ADDENDUM A

Final Remedial Action Plan
DOE-EM/GJ1547
March 2024

DOE Responses to NRC Comments

ADDENDUM A – NRC COMMENTS AND DOE RESPONSES

Figure 7-8. Transition of Disposal Cell Top Cover to Side Slopes

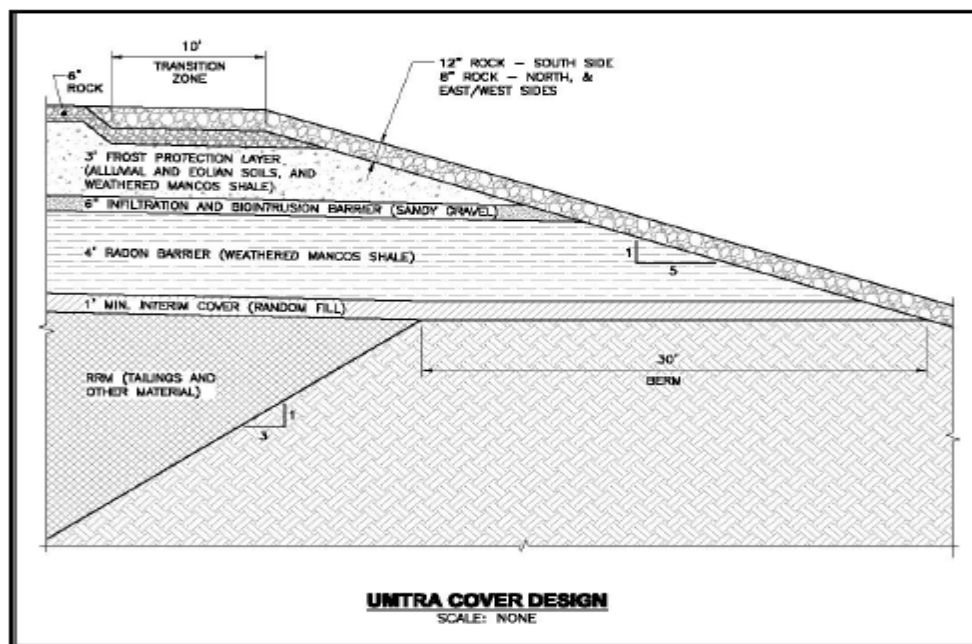
3. Section 5.1.1, "Cover Thickness and Layer Data," states, "Two different surface admixture thicknesses (18 inch and 24 inch) were computed dependent on the slope lengths (Figure 5)." Consider adding a figure similar to FRAP Figure 7-8, "Transition of Disposal Cell Top Cover to Side Slopes," to show the final alternative cover profile where the top cover transitions to the side slopes.

A: A final decision has not been made on the cover profile - whether multiple profiles or a single profile will be used. Given that we will consider adding the suggested figure to the report in the 90% submittal.

Figure 1. Proposed ET Cover with 2ft Surface Admixture Layer

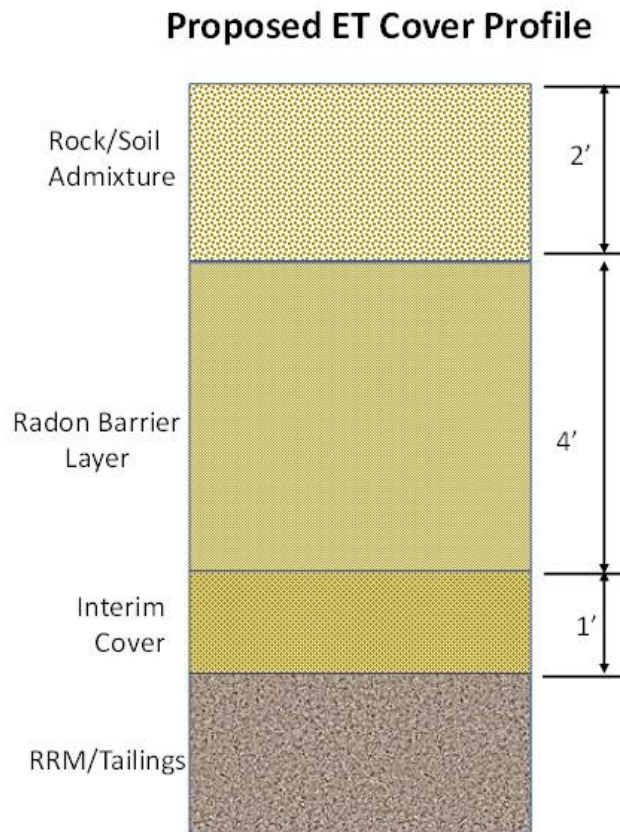
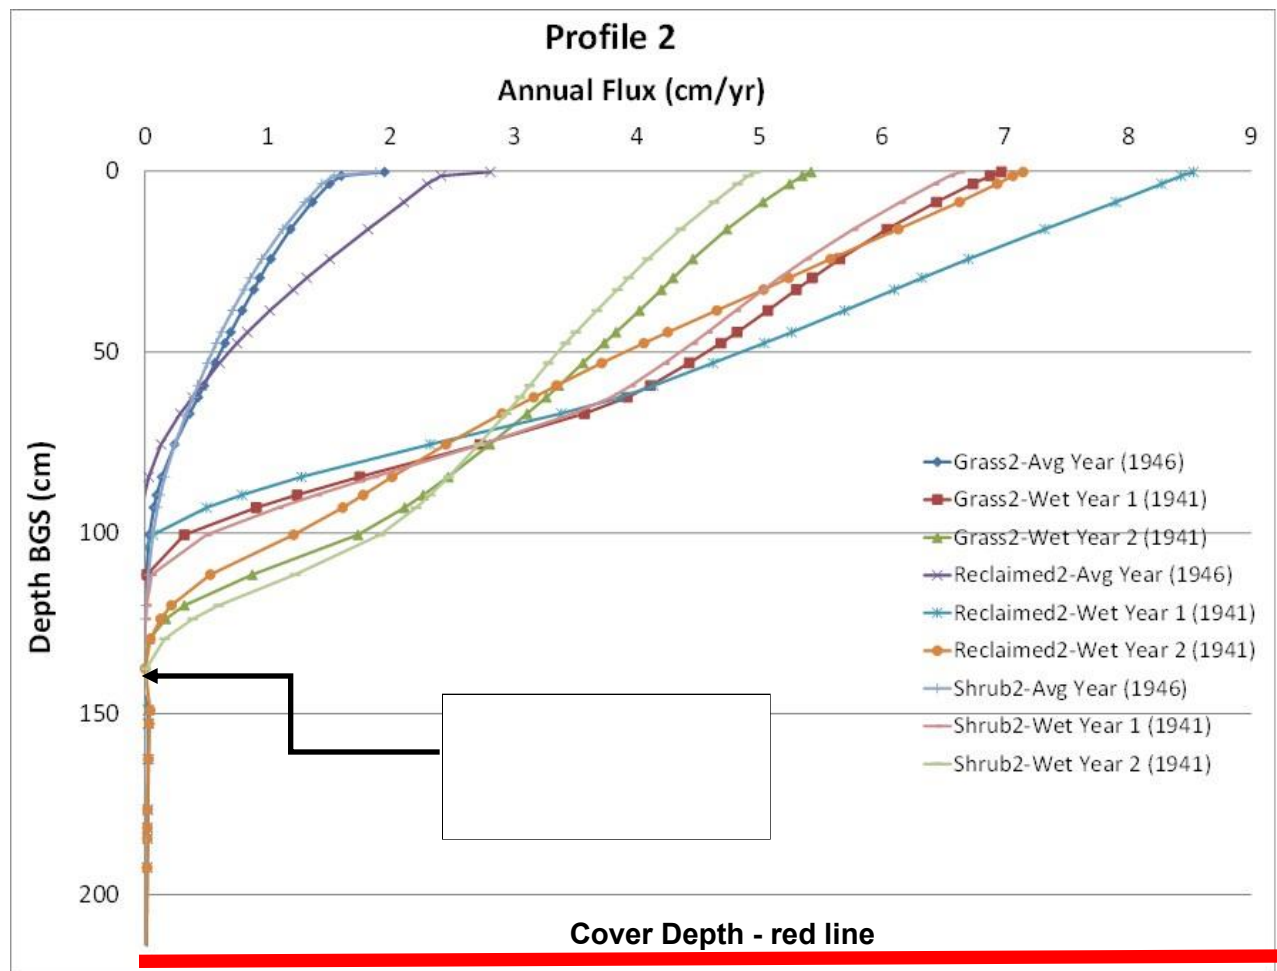
The combined worst case input parameters (soil and vegetation) are included in the

Profile 2 graph that shows the PODR for the beyond worst-case scenario whereby the wettest year on record while forcing 100% infiltration of all precipitation was applied in consecutive years. The output from these sensitivity analyses showed little sensitivity to the soil input parameters. The worst-case soil texture with the worst-case vegetation parameters subjected to the beyond worst-case climate scenario resulted in a PODR of 140 cm. That is, zero flux is produced with a cover depth of 140 cm (PODR was 89cm to 140 cm depending on the soil textures utilized as input -- refer to the Design Report, Appendix B, Table B-10). Additional sensitivity analyses performed utilizing Grand Junction soil properties suggested in a previous review resulted in a worst case PODR of only 109cm (PODR was 83cm to 109cm). Our cover depth is 213 cm. Consequently, water balance is not driving the depth of cover and further altering soil texture or vegetation properties will have no impact on the cover design. Keep in mind that if one simply compares the proposed cover design results to the existing UMTRA cover profile - the proposed ET Cover reduces recharge to zero while the existing UMTRA cover profile allows recharge at close to the precipitation rate at the site.

Figure 7. Climate Demand for Water (PET) v. Climate Supply of Water (Precipitation)

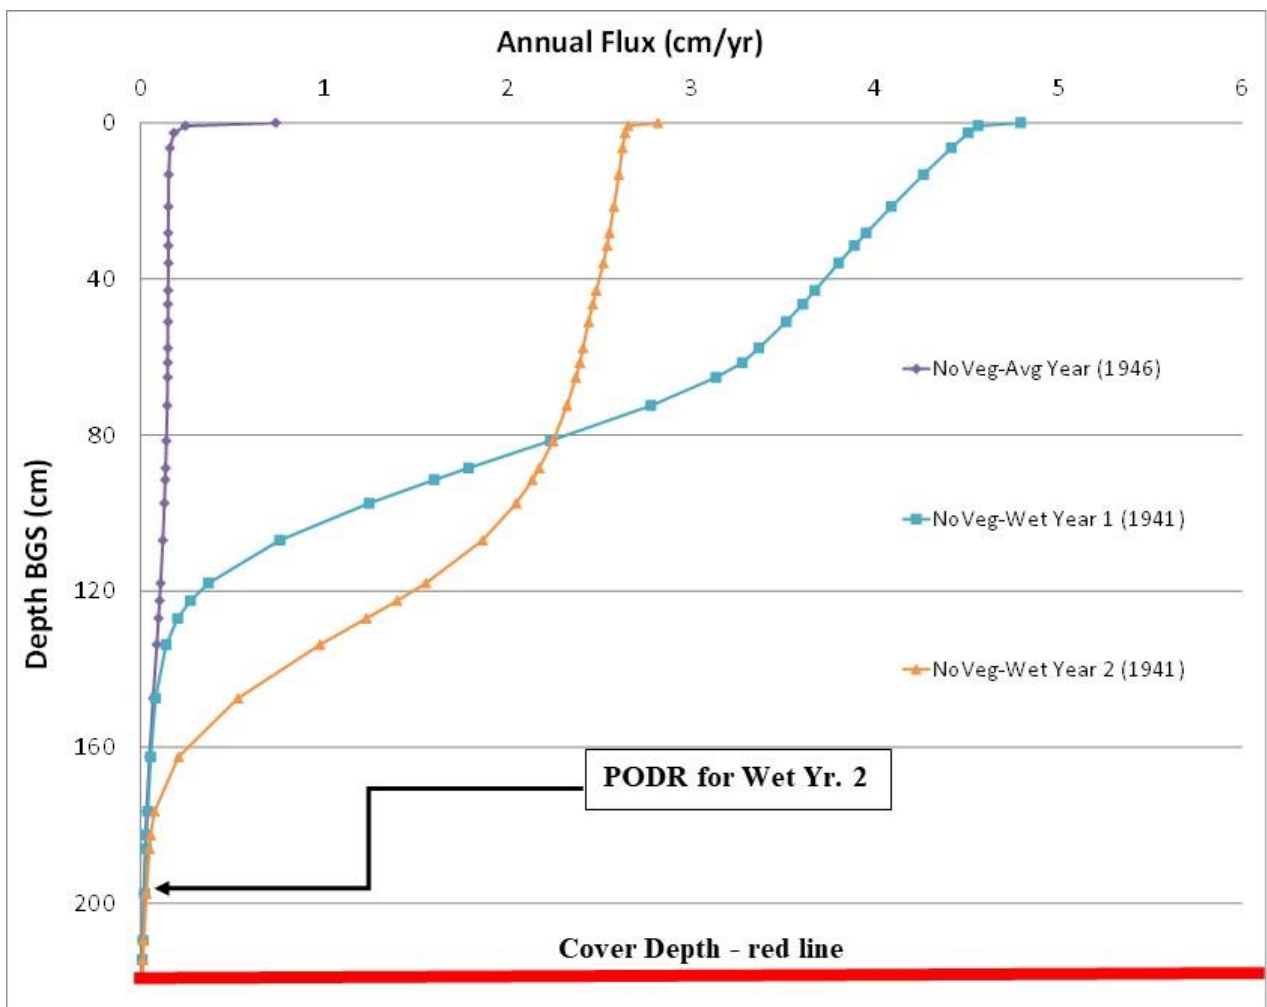
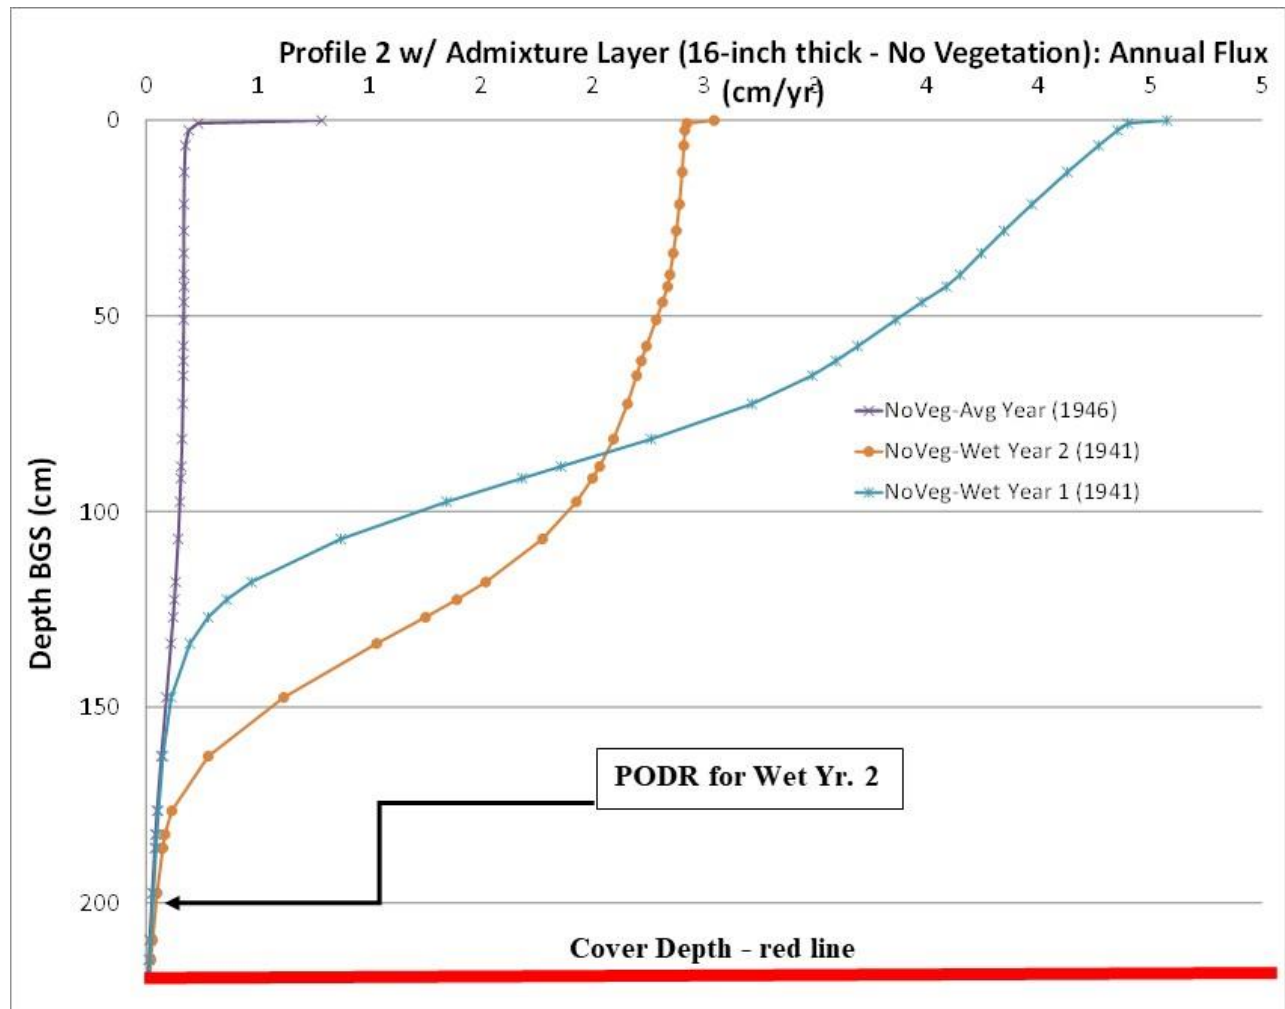
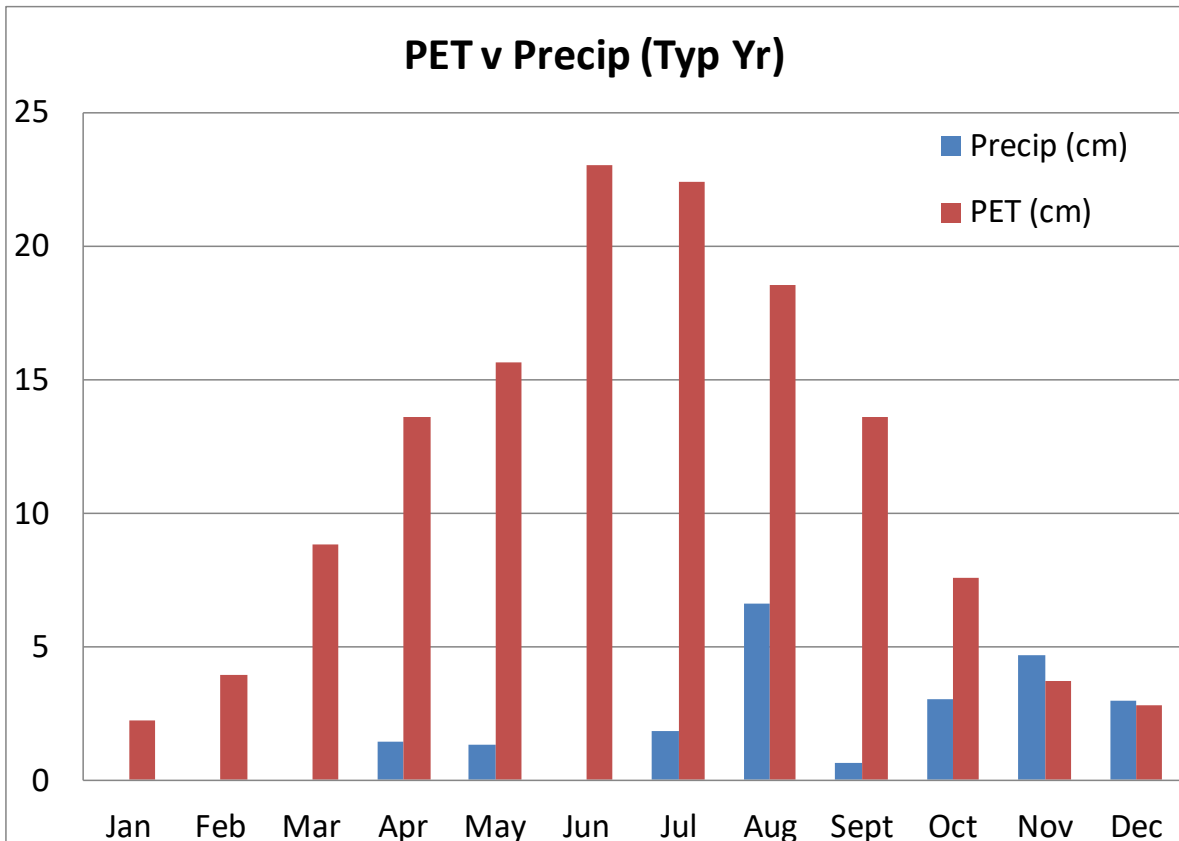
2. Based on the information regarding the potential for biointrusion at the site, as requested above, justify the removal of the biointrusion rock layer at a depth of 3.5-foot as shown in Figure 1 of Section 1, "Existing Final Cover System." Furthermore, discuss the protective measures (e.g., rock material, adequate soil thickness) that will be incorporated in the cover design to minimize cover degradation from the anticipated burrowing and root penetration. Section 11, "Biointrusion," states that the "rock/soil admixture layer of 2.3-inch-diameter D50 rock, which composes 30 percent of the volume of this surface layer, will discourage burrowing of small mammals." However, Albright et al., 2010, referencing Cline et al., 1981, note that prairie dogs and ground squirrels have burrowed more than 200 millimeters into crushed rock layers with a D50 of 60 millimeters or less. They further note that "larger rock would be needed to stop larger animals such as prairie dogs and badgers."

Vegetation is not critical to the design of the cover for erosion nor water balance. Thus, no success criteria have been established. Refer to the graph showing that the annual flux rate estimated for the ET Cover profile without any vegetation is zero (Figure 5). Also refer to the comparison of the PET (demand for water) for the site compared to the precipitation (supply of water) whereby the demand for water is about 6 times greater than the actual supply of water (Figure 6). Thus, a well-designed ET Cover without ponding should produce no percolation with or without vegetation. A graph summarizing modeling results for the modified cover profile with a thinner (16inch) surface admixture is also showed here for information - results show that the PODR is also satisfied within the cover profile depth (Figure 7).
